THE GLIDING FEDERATION OF AUSTRALIA

GFA AN 121
(ISSUE 1)

AIRWORTHINESS ADVICE NOTICE

TYPE AFFECTED: ES 59 Arrow.

FIGURE 1 MAIN FITTINGS FROM FUSELAGE

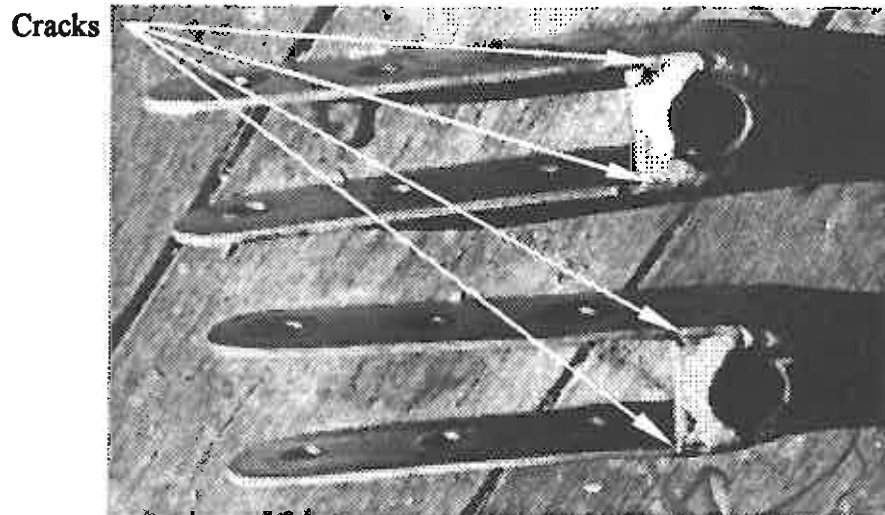
2. **Main wing fitting cracks.** A number of cases have been reported of cracking of the main wing attachment fittings on both the fuselage and the wing at the places shown in Figures 1 and 2.

If these cracks are found then the cracks should be ground out and rewelded.
